Agenda Item 3
545 Whitehall Lane

Request for Extension of Previous Approval
New Single-Family Residence on a Vacant Lot

Subject: **545 Whitehall Lane – Request for an Extension of Approval**

Excerpt
The City of Lake Forest
Building Review Board
Proceedings of February 7, 2024 Meeting

AUTOTURN STUDY

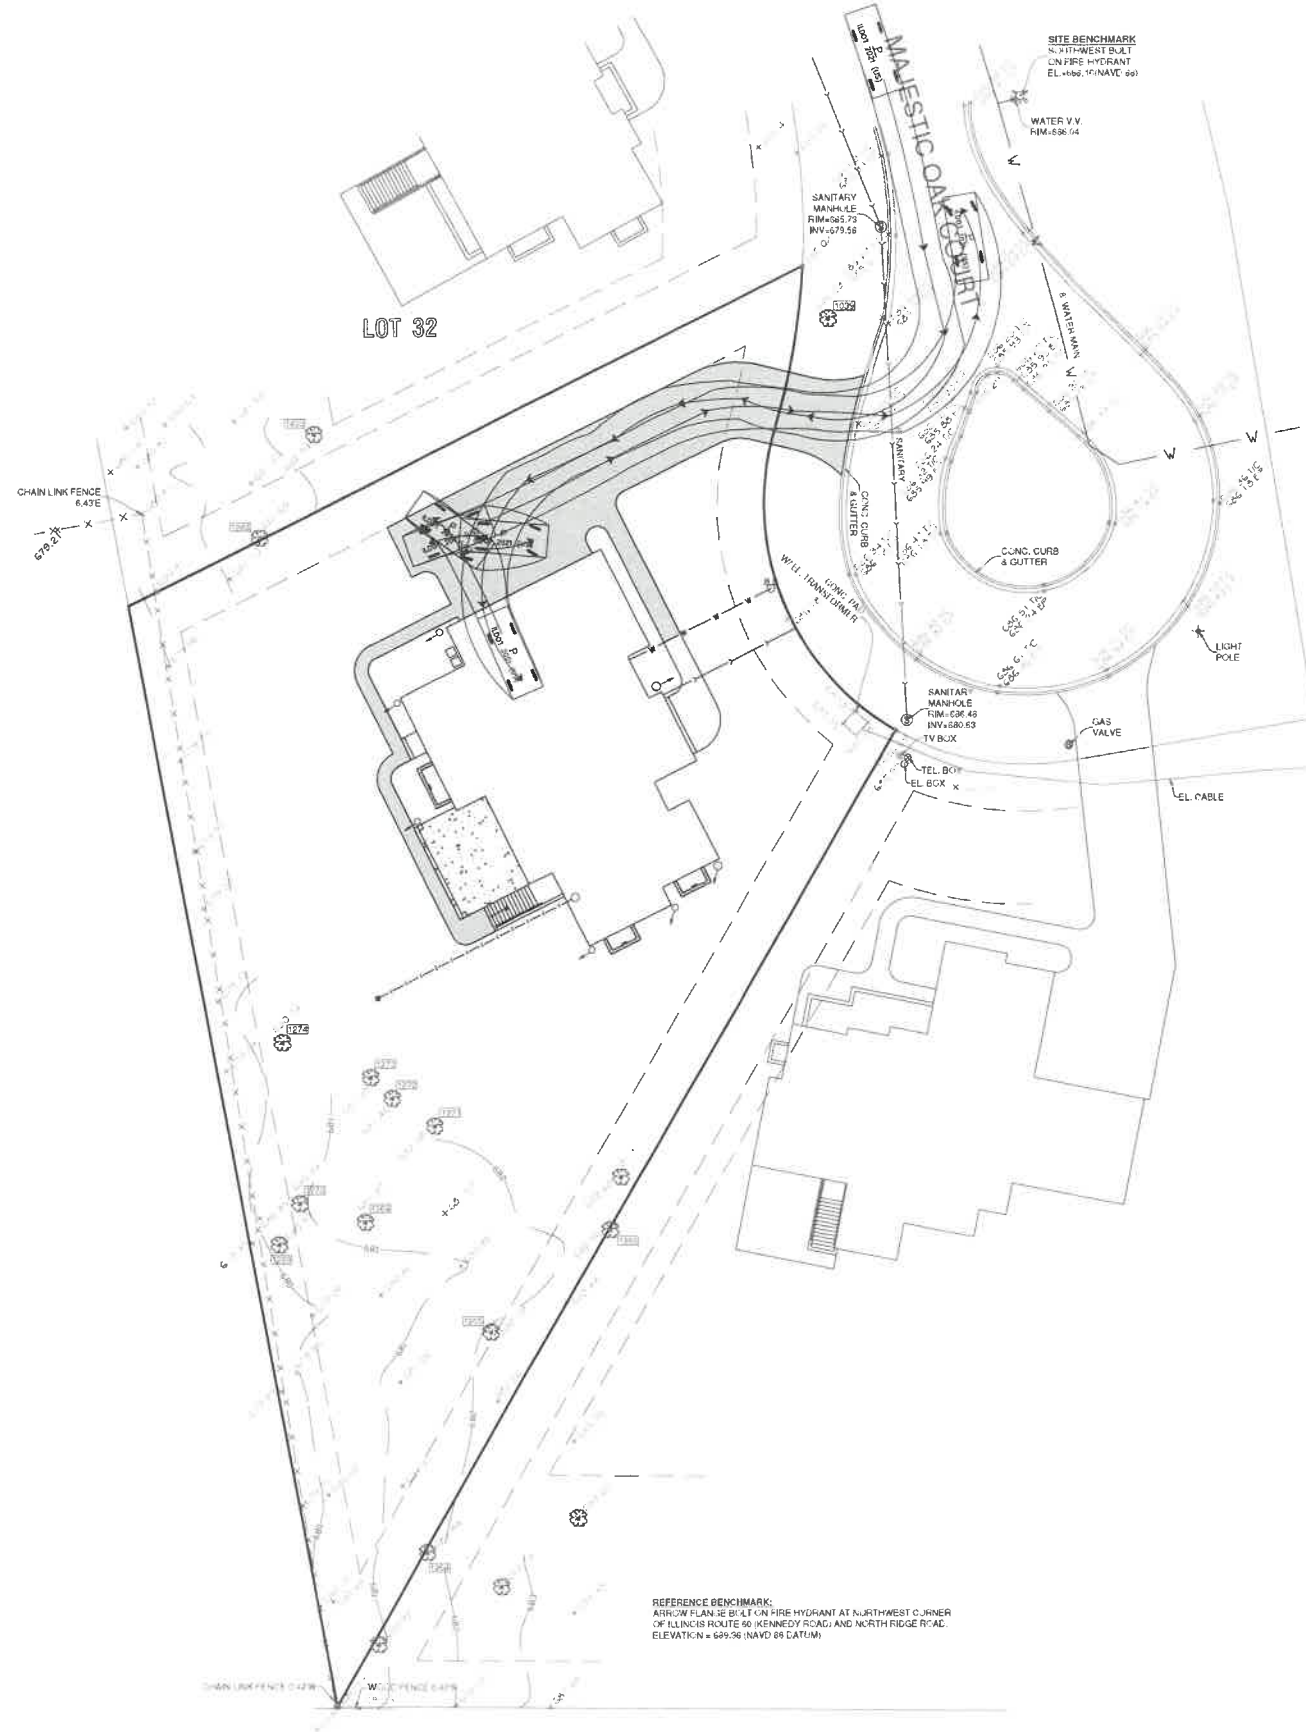
In response to direction from the Board, an auto-turn study prepared by a licensed engineer verifying that the garage apron is adequately sized for functionality is included in the packet provided to the Board.

FRONT ELEVATION

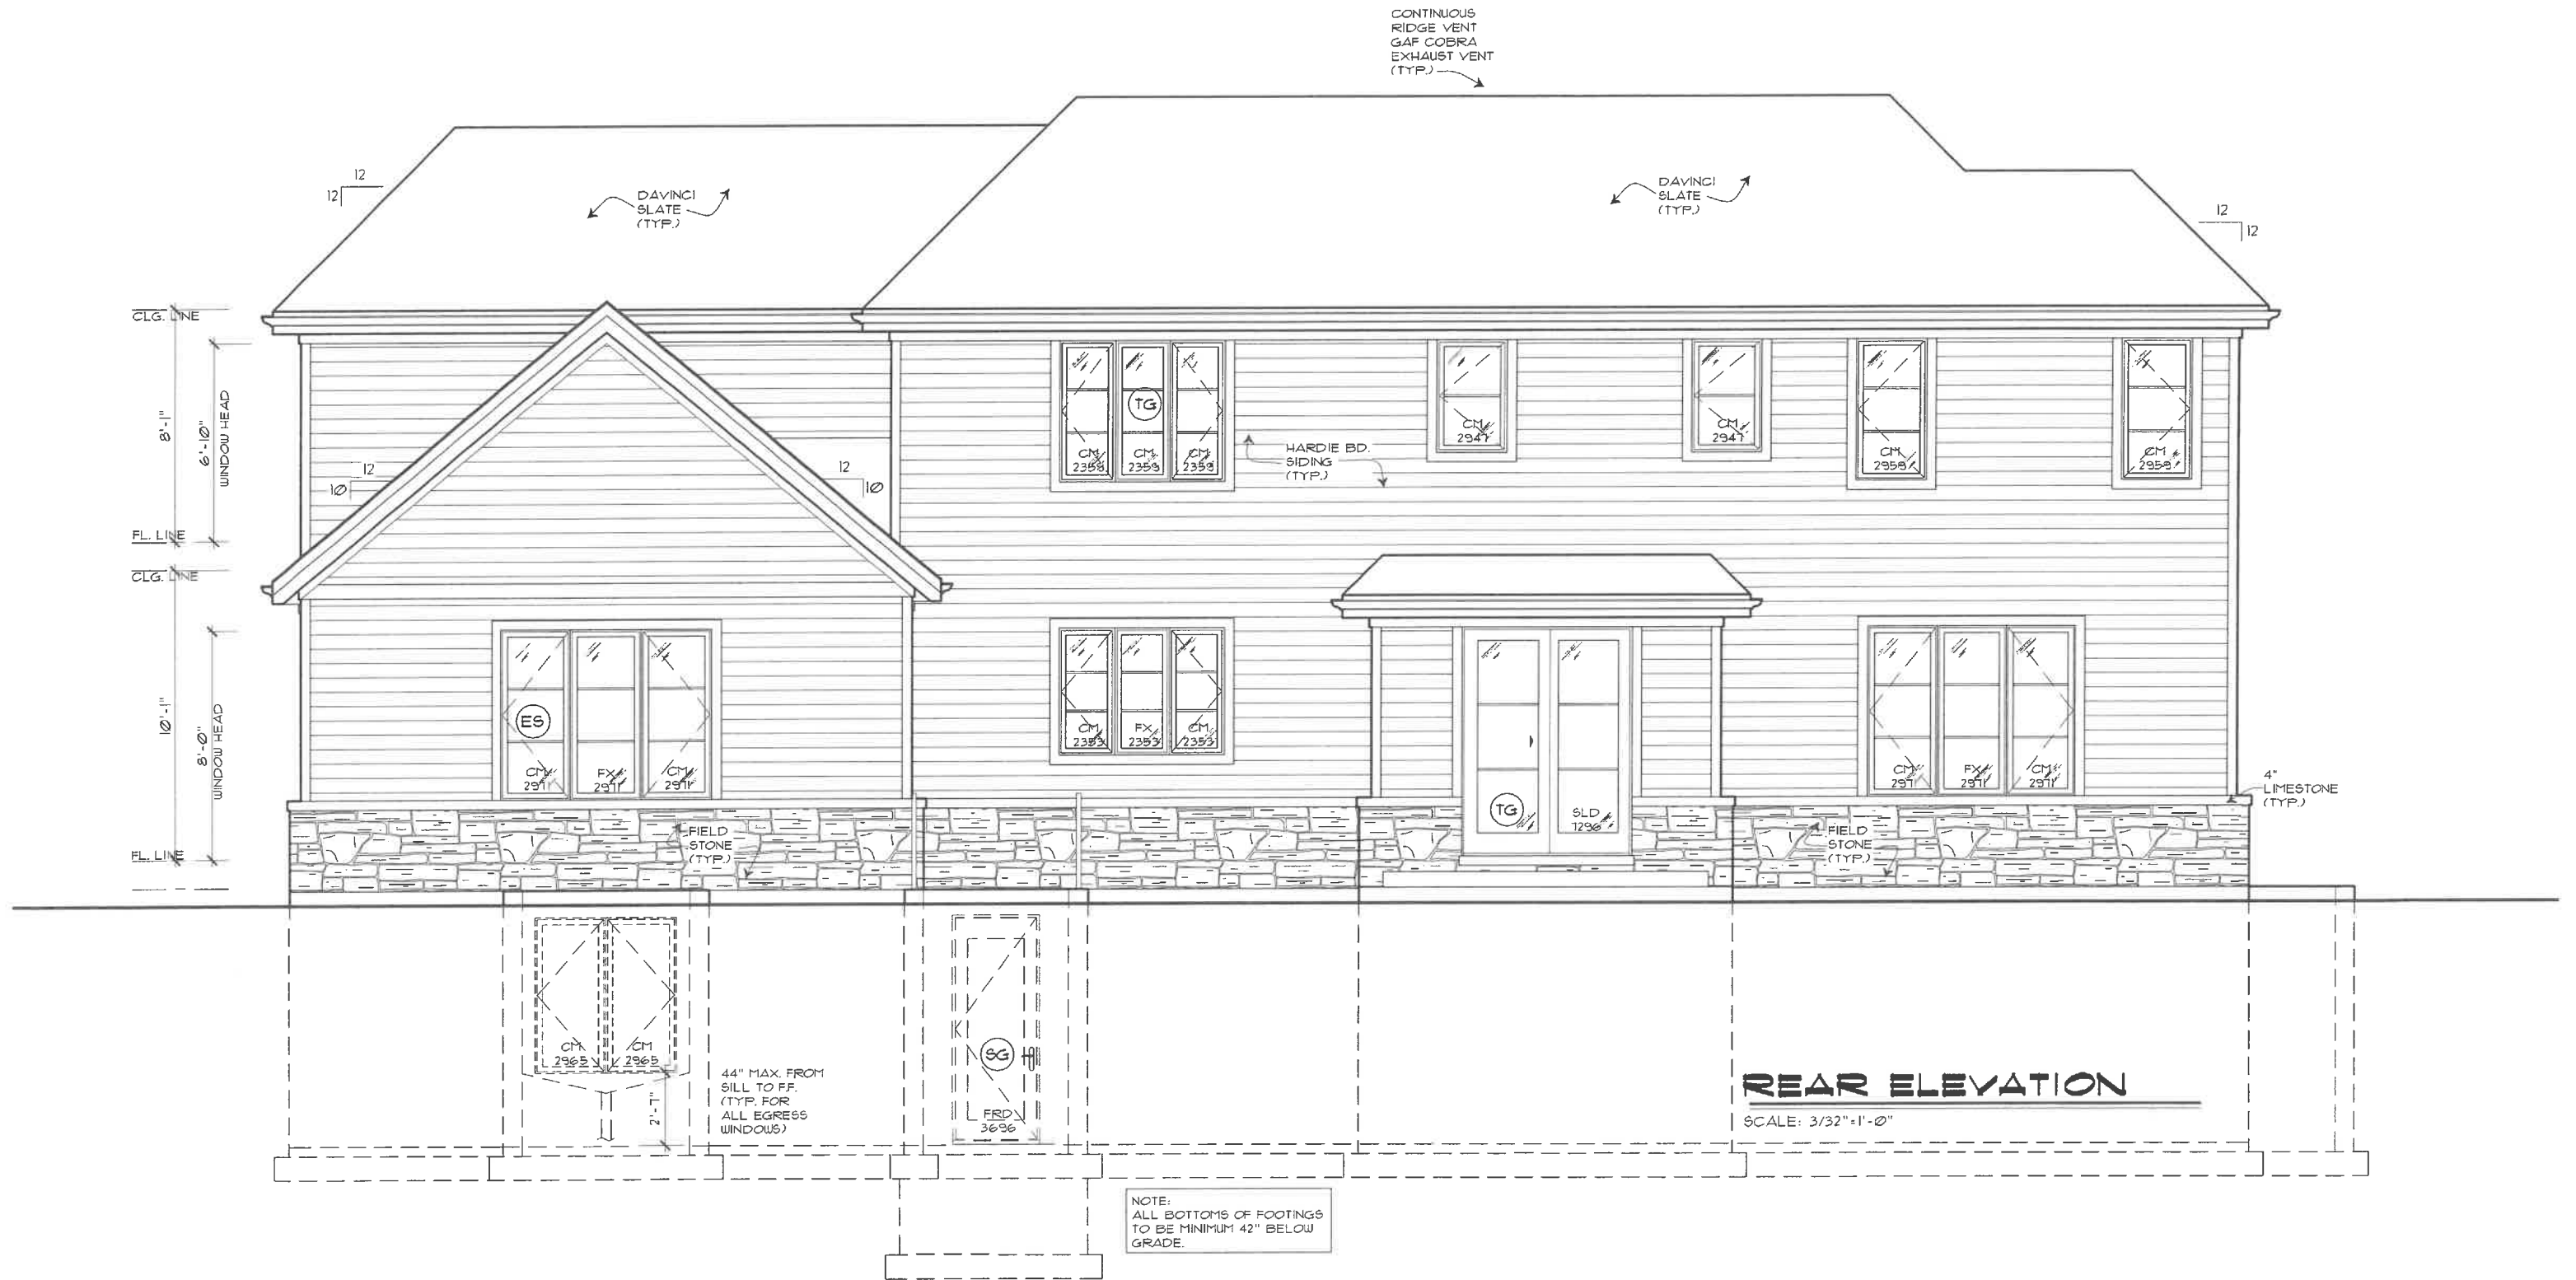
Staff Recommendation: Detail the window trim material as wood, such as cedar, rather than LP.

NOTE:
 ALL TRIMS TO BE CEDAR.
 ALL THE WINDOWS MUNTINS
 TO BE SIMULATED DIVIDED
 LITES WITH INTERIOR AND
 EXTERIOR MUNTIN BARS
 AFFIXED.
